**LEANDER CITY COUNCIL  
and  
PLANNING & ZONING COMMISSION  
JOINT WORKSESSION  
CITY OF LEANDER, TEXAS  
Pat Bryson Municipal Hall  
201 N. Brushy Street  
Leander, Texas 78641**

Tuesday ~ March 18, 2014 at 6:00 p.m.

SECTOR MAP  
with PERMITTED COMMUNITY UNITS  
FEBRUARY 26, 2014

## **EXECUTIVE SUMMARY – Concerns regarding Leander Smart Code and Transit Oriented Development District**

**SECTOR MAP with PERMITTED COMMUNITY UNITS**  
FEBRUARY 26, 2014

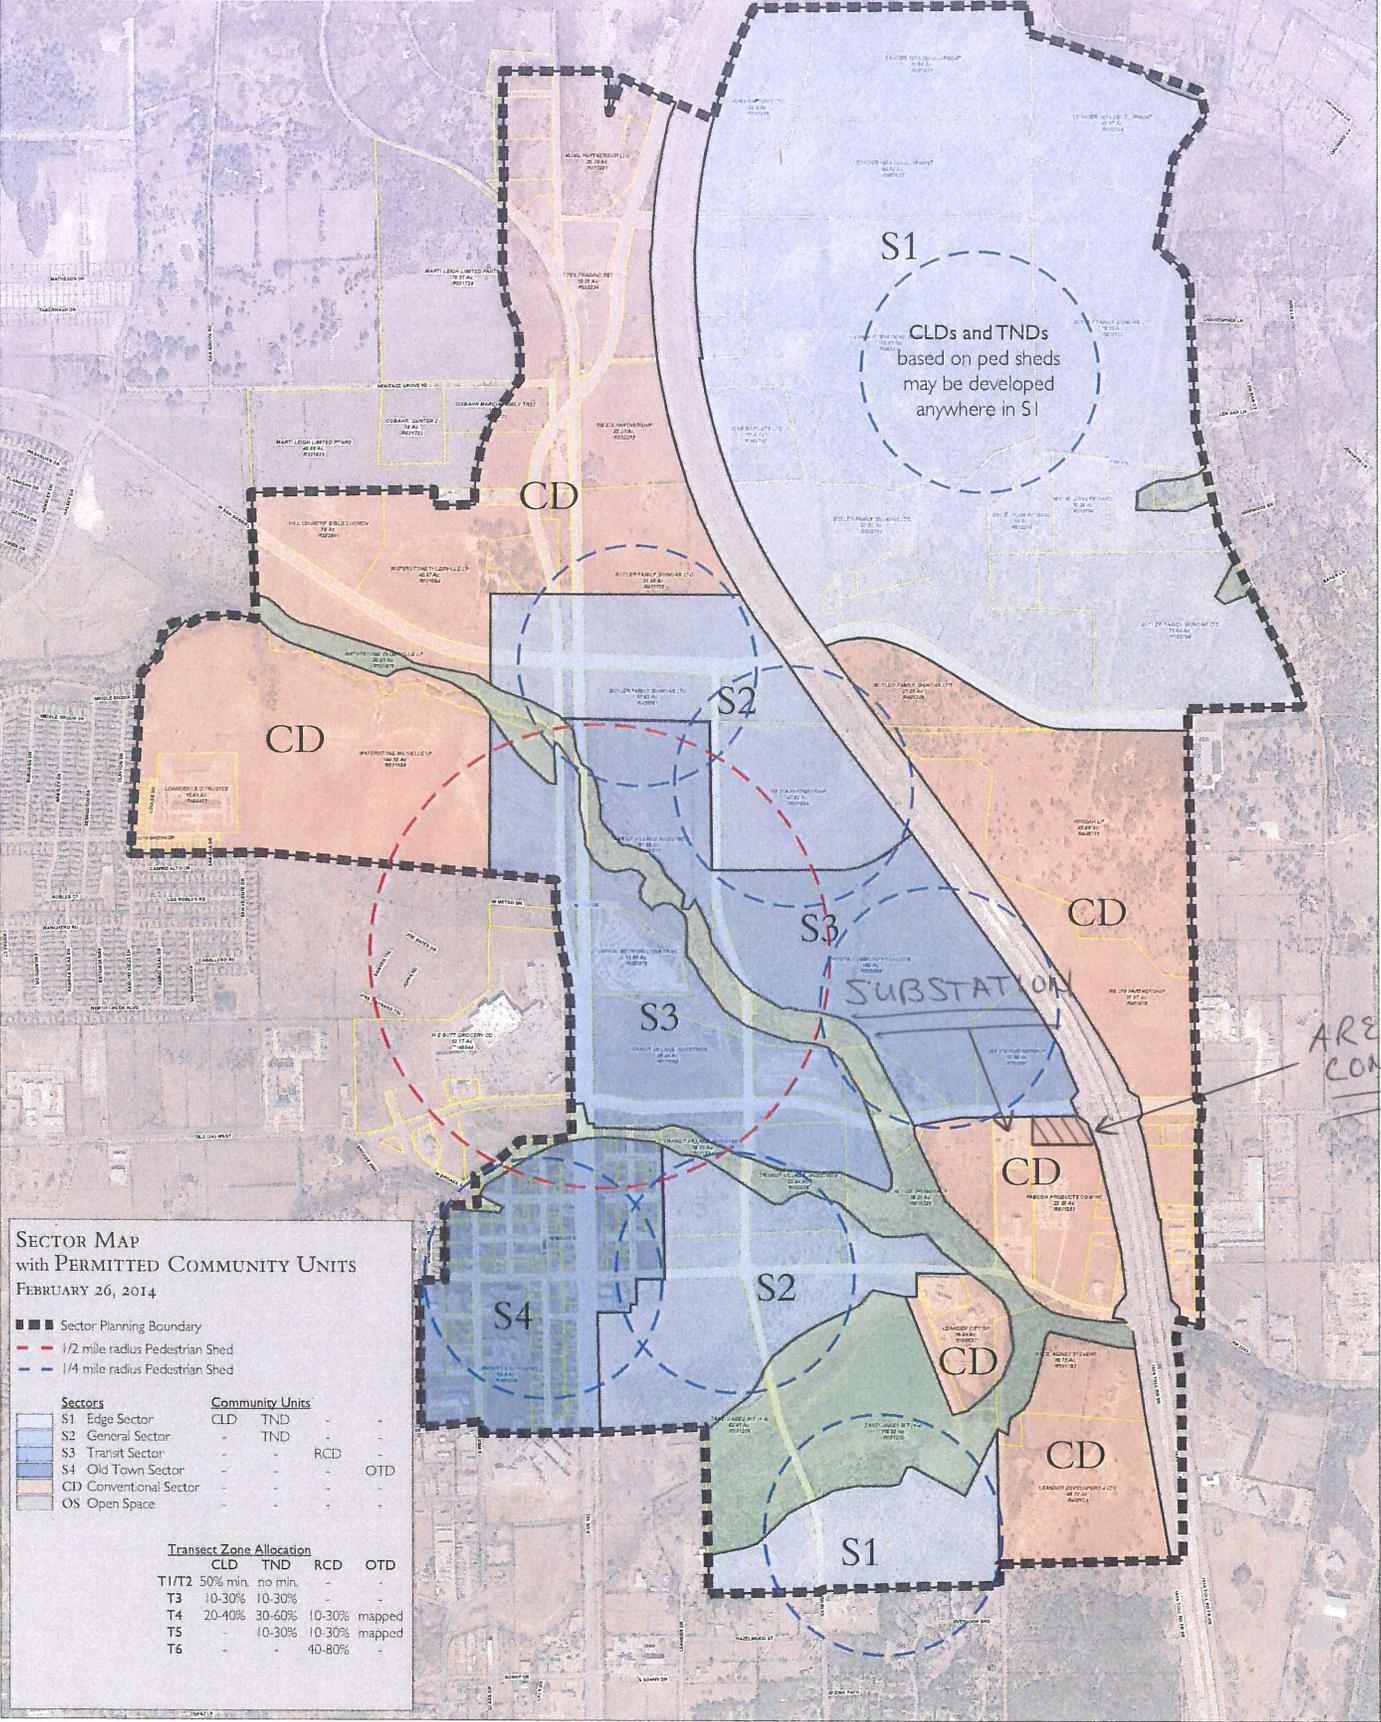
The comment that has me concerned was that she (the council member) felt that my property along Hero Way should be zoned S3 (Transit Sector) and be again governed by the Smart Code. I believe her comment was that Hero Way should be "blue on both sides of the road" on the new TOD map. In other words, my contiguous 23 acres should have two zones called out on the map. I am attaching a copy of the new map to this letter with the area affected highlighted.

I respectfully request that this not occur for the following reasons:

1) I believe that the borders where two sections meet should be clean. The zone borders should be clearly defined by roads or other geographical features. One zone should not be allowed to bleed or seep into another.

2) The area in question has a 100' PEC public utility easement associated with it. The easement runs right along the northern edge of the property along Hero Way. The easement is associated with the electrical substation nearby. It does not seem to be logical to designate a utility easement as S3 on the new TOD/Smart Code map.

CD4 PROPERTY REFERENCE

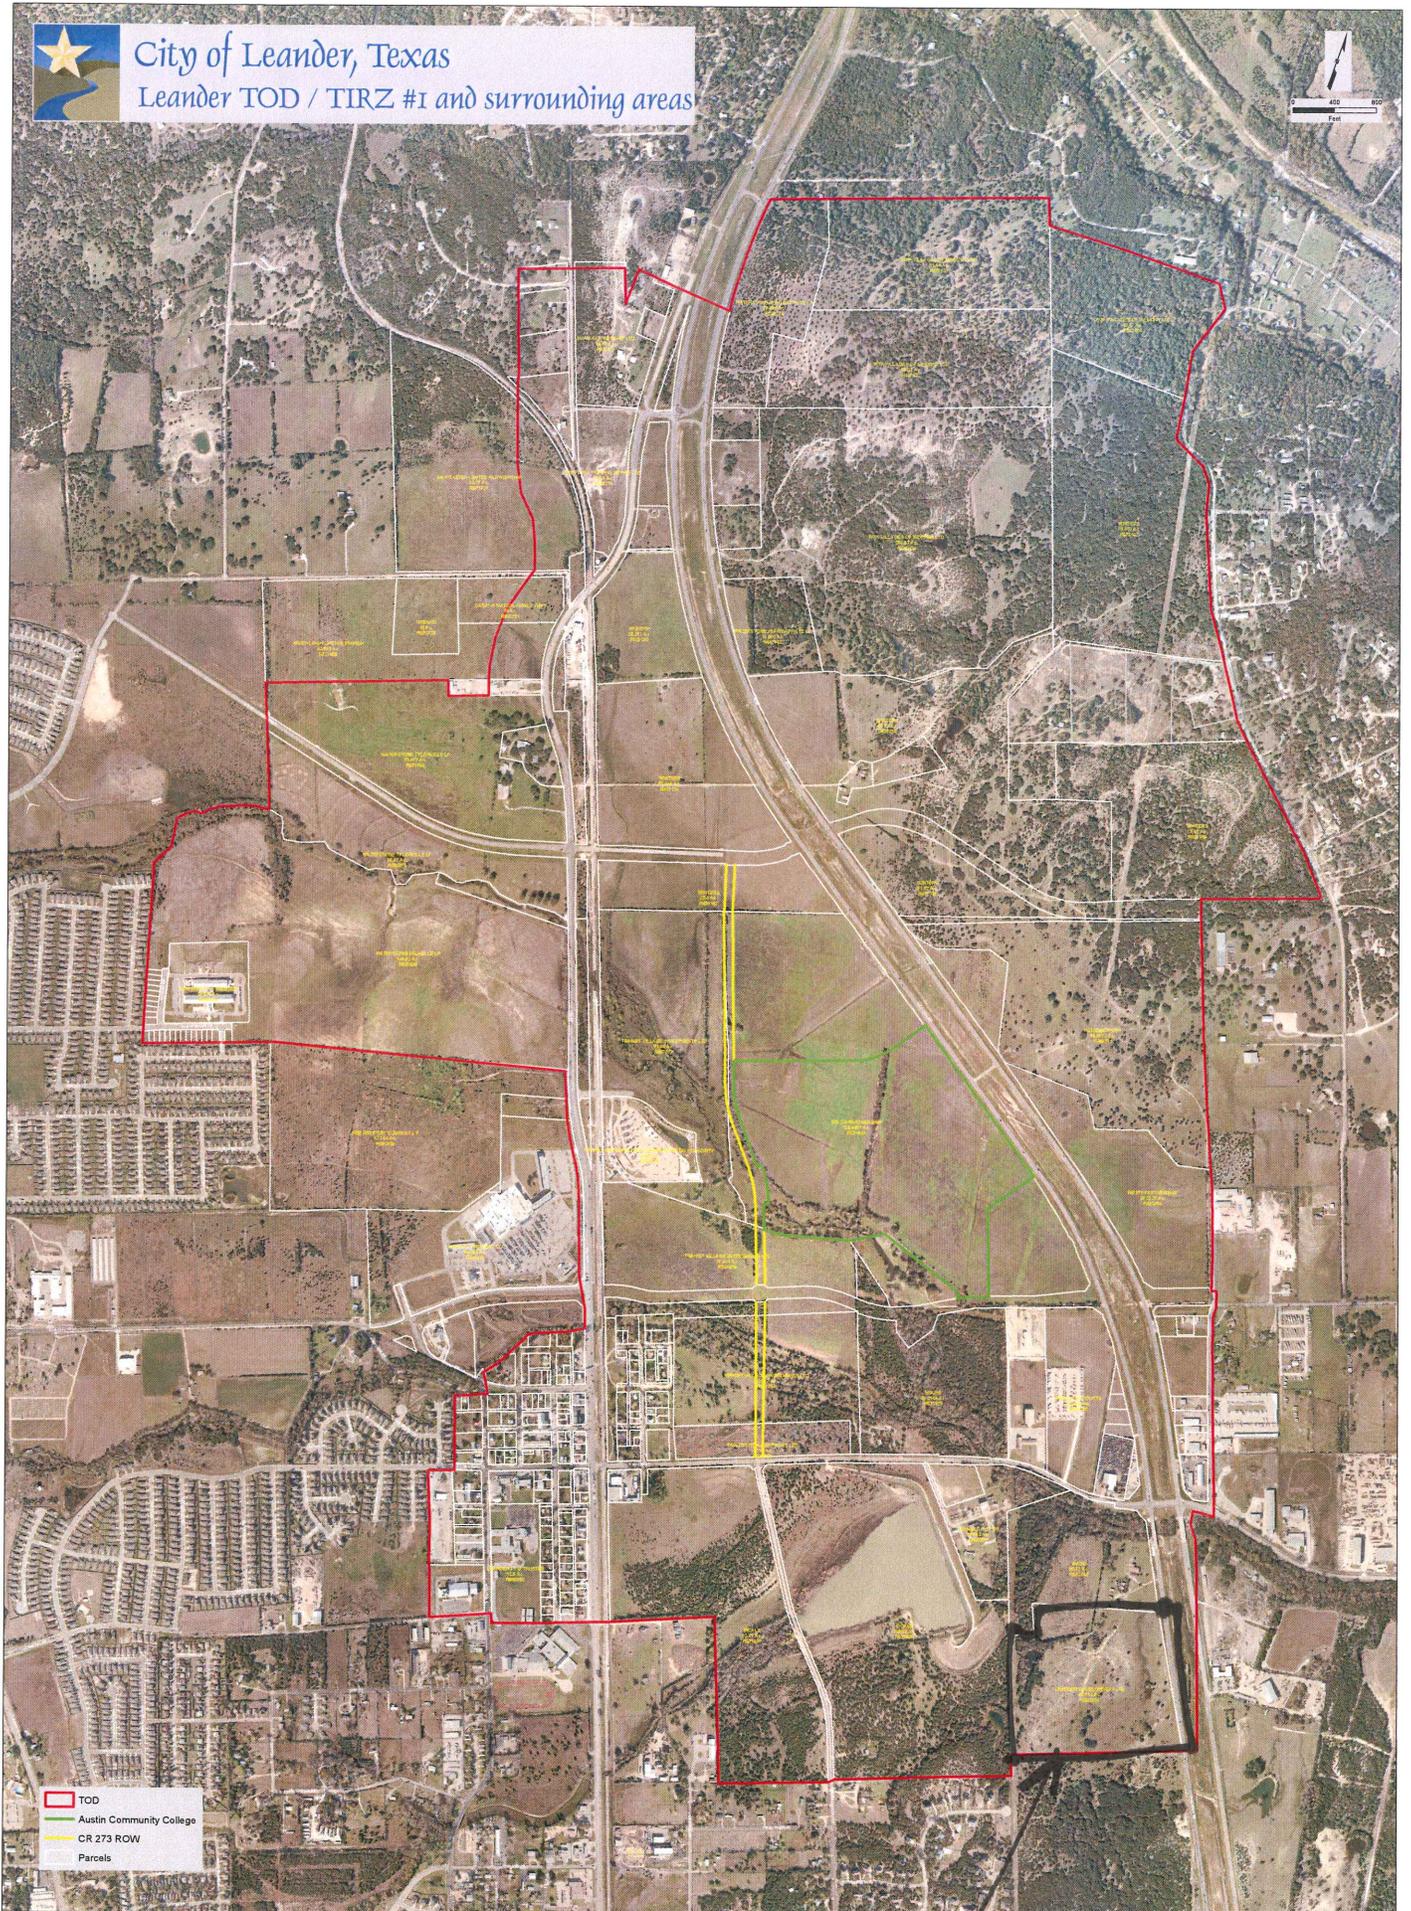
Unfortunately, this has not been the case. It has been our experience that potential buyers of our TOD property are put off by the Smart Code. We also believe, given the distance between our property (south of 2243 on 183A) and the train station, that the area covered by the Smart Code is too big and should not include our property.

As a result, we respectfully request that our property (shown on the enclosed map) be removed from the area covered by the Smart Code during the ongoing Smart Code revision process. We ask, respectfully, that our property be covered by conventional zoning in the future.
